Contract No. and Title:  
Agreement No. CE 1/2013(CE)  
Site Formation and Associated Infrastructural Works for Development of Columbarium, Crematorium and Related Facilities at Sandy Ridge Cemetery - Design and Construction

Drawing title  
Layout Comparison - Original Design and Current Design

Drawing no. <b>Figure 2.2a</b>		Rev. <b>G</b>	
Drawn GL	Date 03/16	Checked EL	Approved ST
Scale AS SHOWN		Status PRELIMINARY

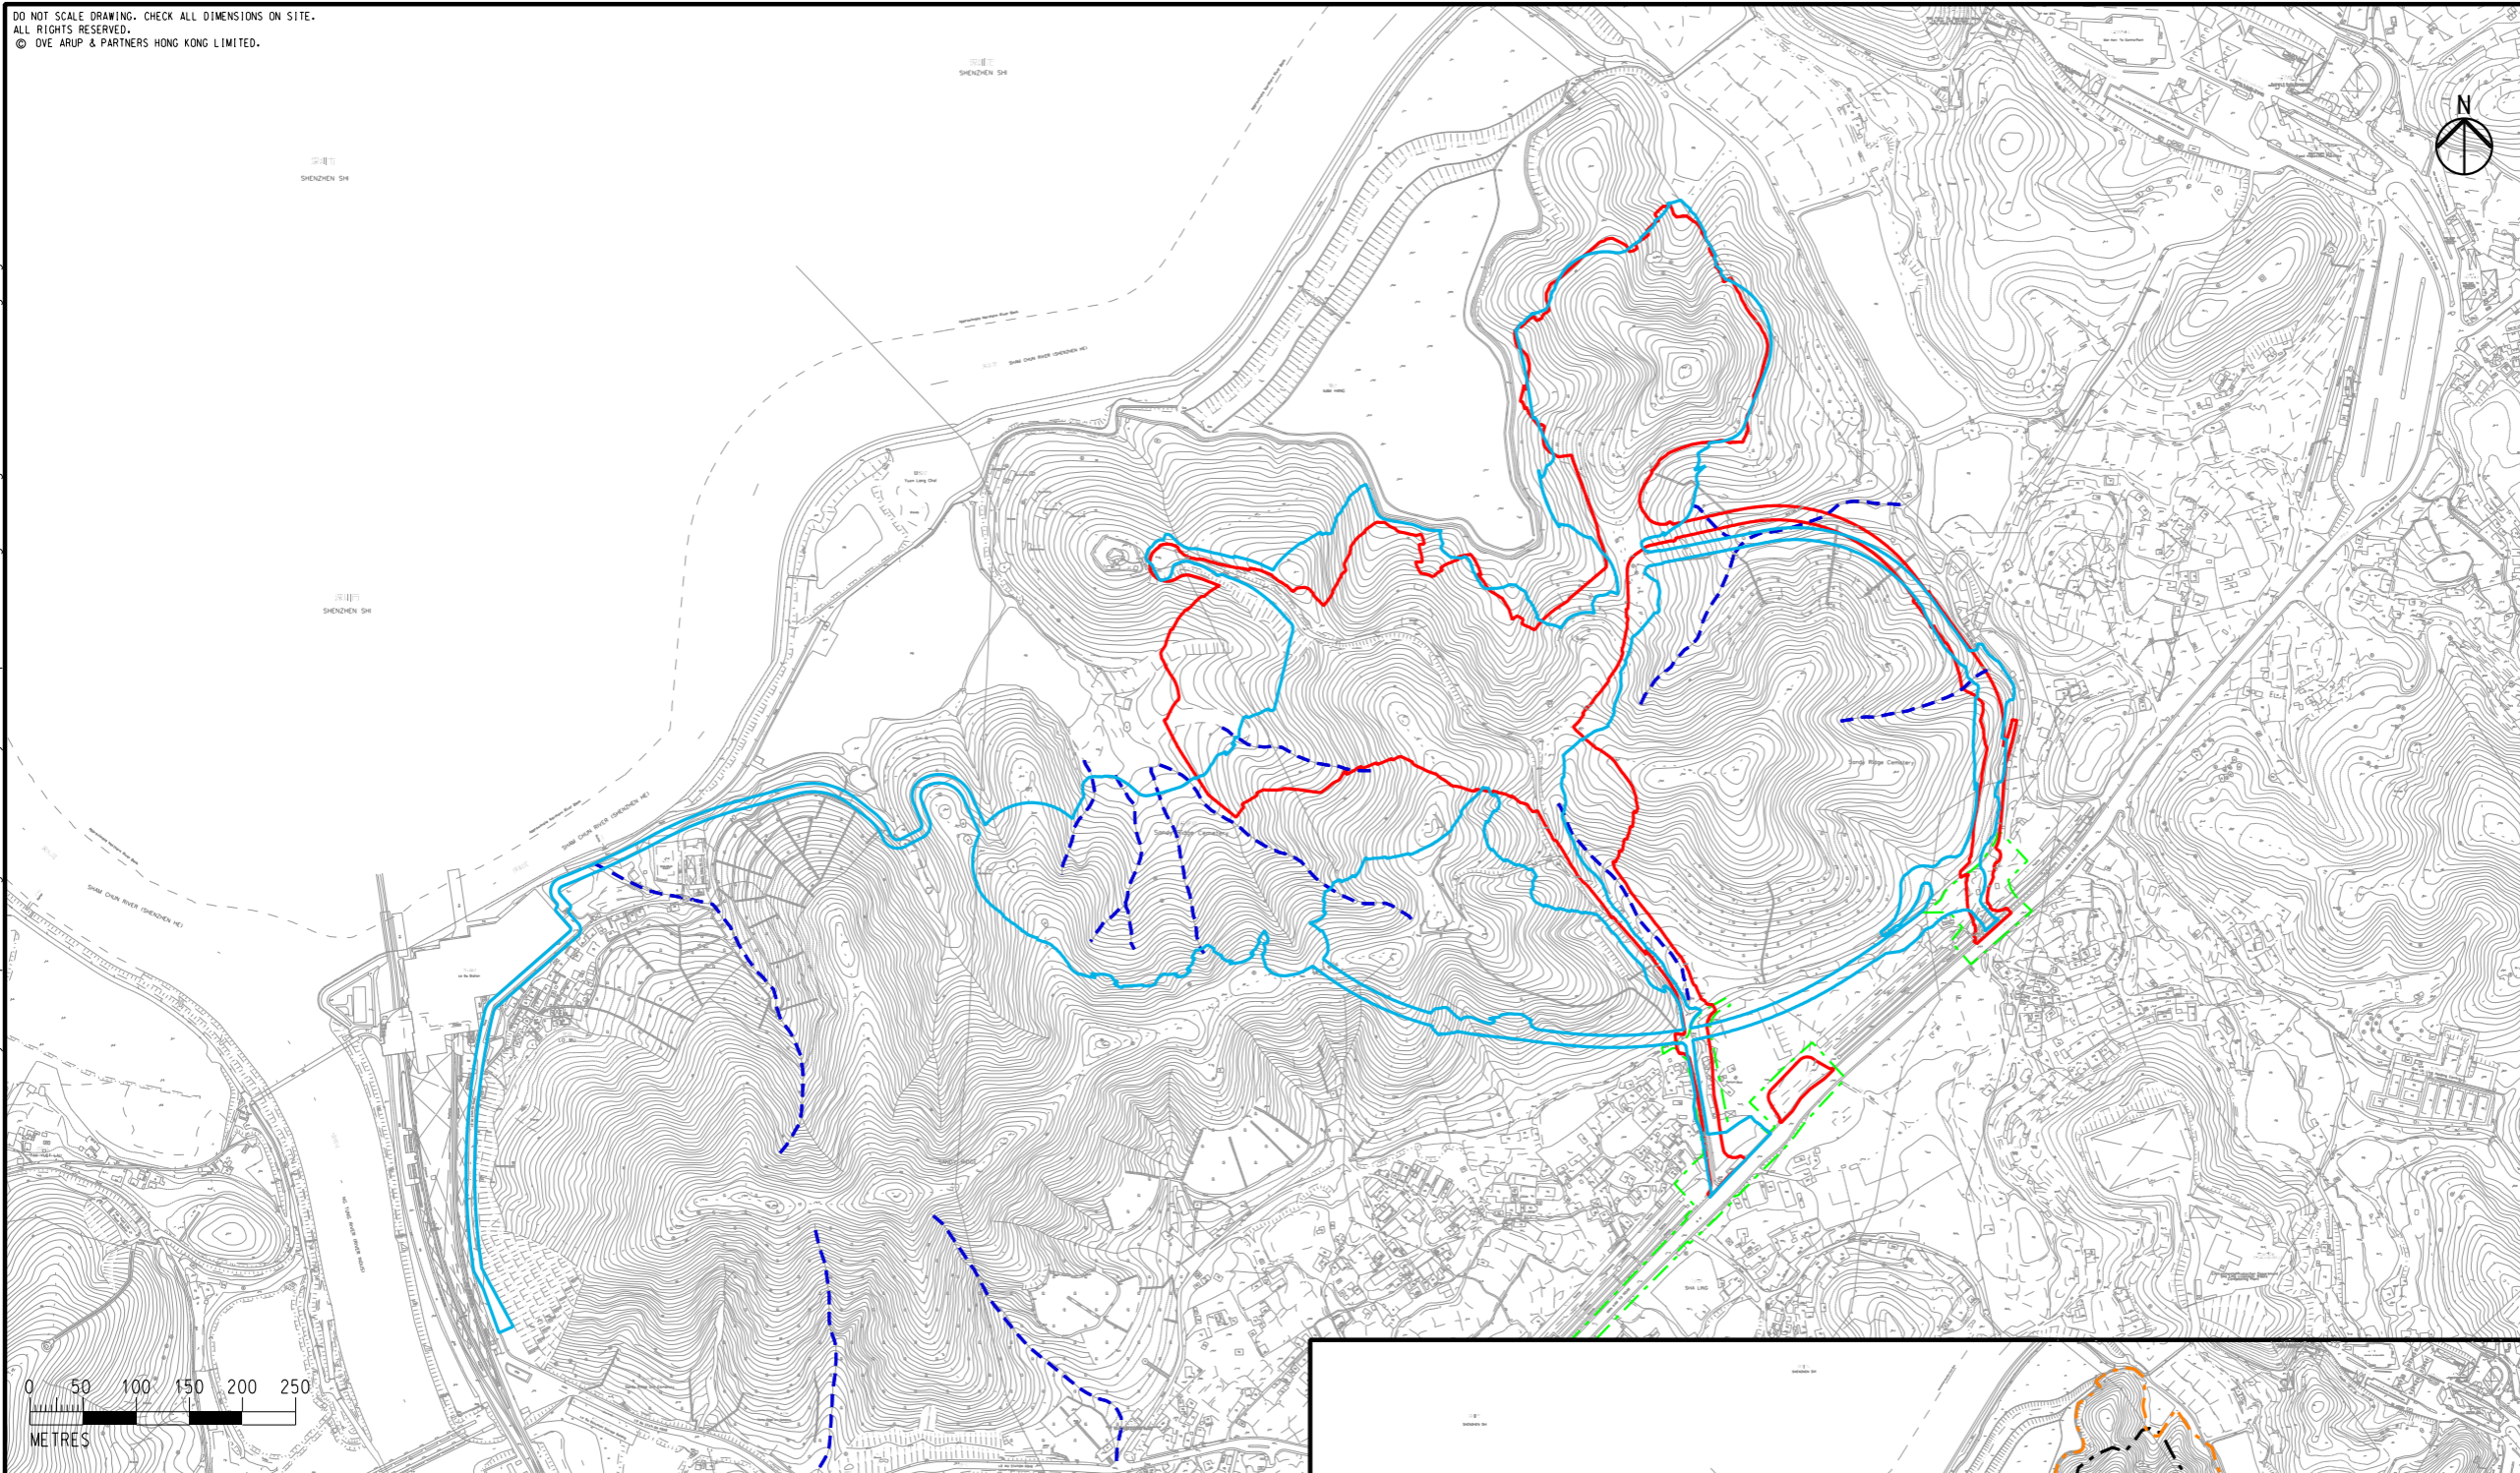
Design changes
Optimization of Platform Configuration	<ul style="list-style-type: none"> <li>Shift platform to avoid direct impacts on wet woodland and seasonal watercourses directly feeding the wet woodland. (Figure 2.2b)</li> <li>Increase the separation distance between the western toe of the slope and the wet woodland by installing a retaining wall and a hammer head arrangement for the emergency access. (Figure 2.2b)</li> </ul>
Optimization of Road Network and Pedestrian Link	<ul style="list-style-type: none"> <li>Redesign platform to avoid direct impacts on clan graves. (Figure 2.3)</li> <li>Upgrade the existing Sha Ling Road. The road tunnel and five of the viaducts in Option A would not be required.</li> <li>Original pedestrian link near MTR Lo Wu Station would not be required.</li> </ul>
Arrangement for Pick-up / Drop-off at MTR Station*	<ul style="list-style-type: none"> <li>Adopt multiple pick-up / drop-off locations at a number of MTR Stations. Major road improvement and excavation works would not be required.</li> <li>Choi Yuen Road widening would not be required.</li> </ul>
